MAGNOLIA SPRINGS SUBDIVISION

APPLICATION NUMBER 6 DATE April 19, 2007

DETAIL SITE PLAN

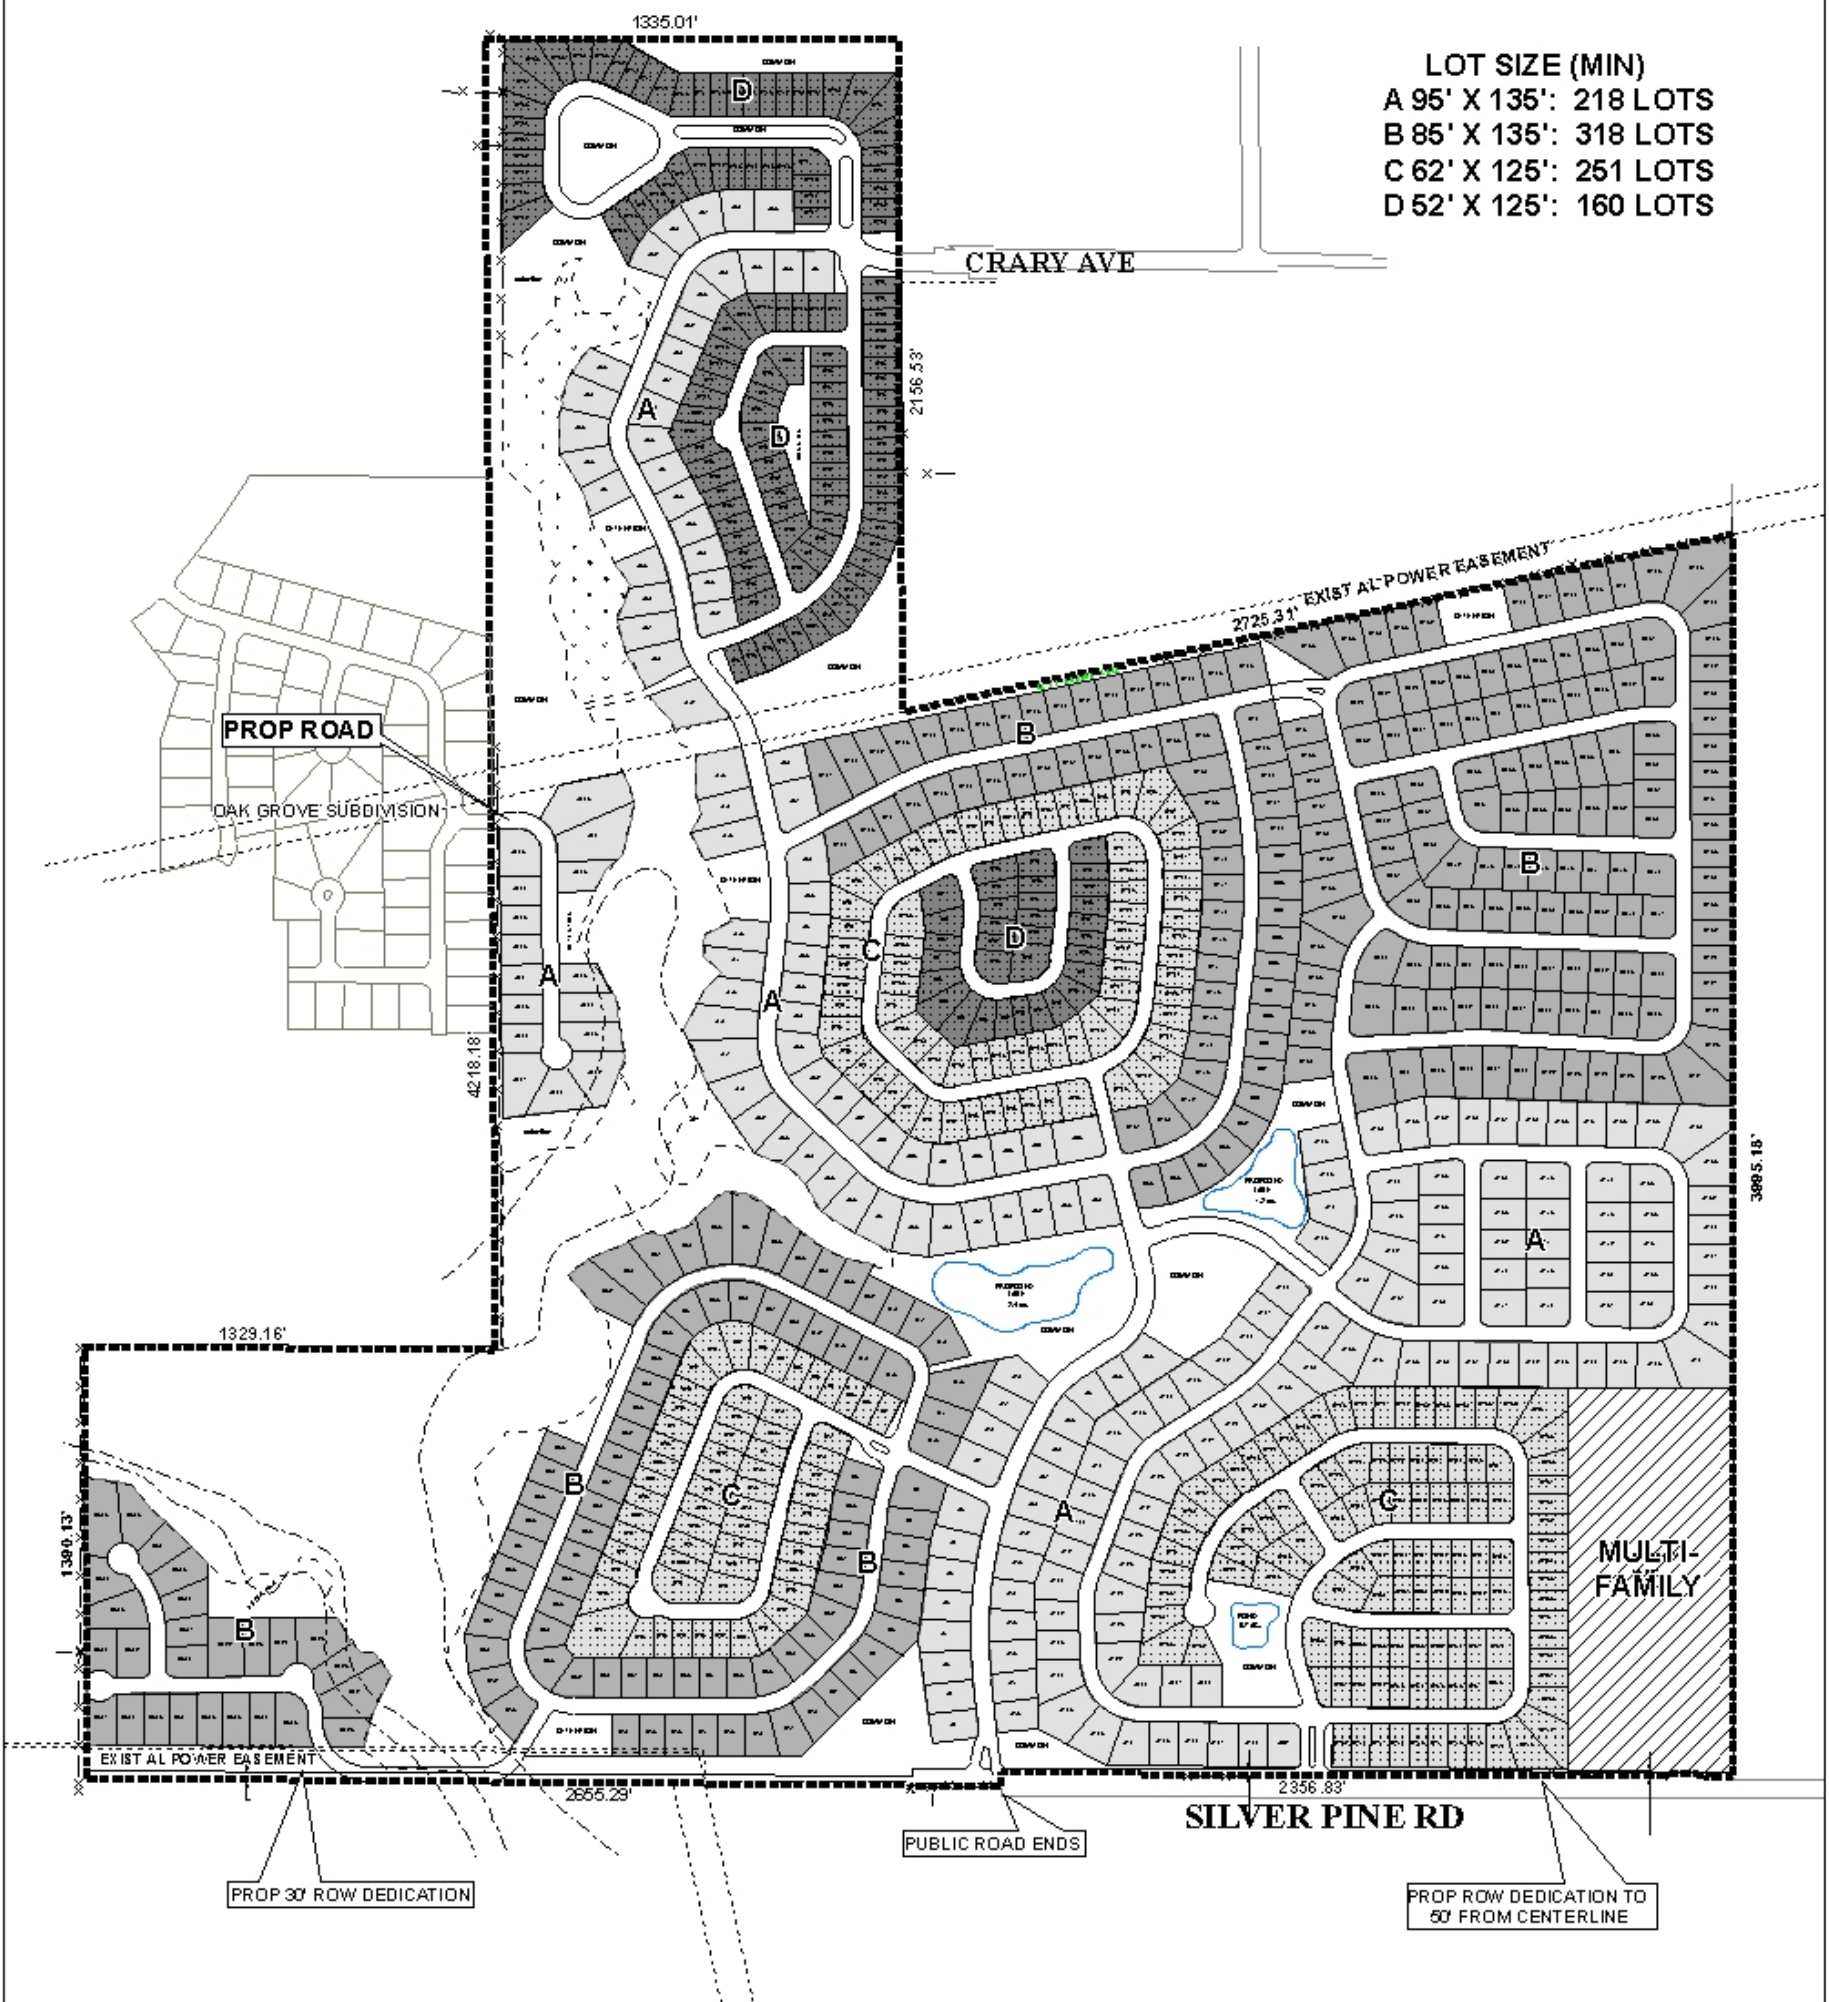
The areas of open space are labeled as common area, as are areas of wetlands, islands or medians in the roadway, areas containing lakes and other amenities, as well as detention areas. All areas not designated as lots should be labeled as common areas, and a note should be required on the final plat, if approved, stating that maintenance of all common areas is the responsibility of the property owners (association).

There is one minor point of concern relating to the configuration; the location of the proposed road connecting the westernmost unit to the rest of the proposed development. While that roadway is within dedicated right-of-way, it is also partially within the right-of-way dedicated for the future extension of Silver Pine Road, but not entirely. This could potentially create an issue when Silver Pine Road is extended in this area.

While the plat reflects compliance/similarity with previous applications/approvals, one issue that is not reflected is the provision of a street stub to the East. Based on the number of lots

proposed, an additional point of access (future) would be desirable. Therefore, if approved, a condition requiring the provision of a street stub to the East would be appropriate. Additionally, given the overall size and number of lots, the subdivision will probably be developed in phases or units. As a phasing plan was not submitted with the application packet, individual applications for each phase or unit should be required to ensure that development occurs in a manner to provide the most points of access in a timely and efficient manner.

1. dedication of sufficient right-of-way along Silver Pine Road to provide 50' from centerline for the portion on the Major Street Plan, and 30' from centerline for the remainder of the future frontage, as shown on the plat submitted;

2. provision of a street stub to the East;
3. coordination with County Engineering regarding the location and design of the proposed road connecting the westernmost unit with the remainder of the development;

4. submission and approval of individual applications for each phase or unit, to ensure that development occurs in a manner to provide the most points of access in a timely and efficient manner;

5. all proposed roads be constructed to county standards, and dedicated to Mobile County;
6. all areas not designated as lots should be labeled as common areas (including wetlands and detention areas), and a note placed on the final plat stating that maintenance of all common areas is the responsibility of the property owners (association);

7. placement of a note on the final plat stating that any lots which are developed commercially (or multi-family residential) and adjoin residentially developed property must provide a buffer, in compliance with Section V.A.7. of the Subdivision Regulations;

8. provision of a certification letter from a licensed engineer to the Planning Section of Urban Development, certifying that the stormwater detention, drainage facilities, and release rate comply with the City of Mobile stormwater and flood control ordinances, prior to the signing and recording of the final plat;

9. labeling of all lots with size in square feet, or placement of a table on the plat containing the lot size information.
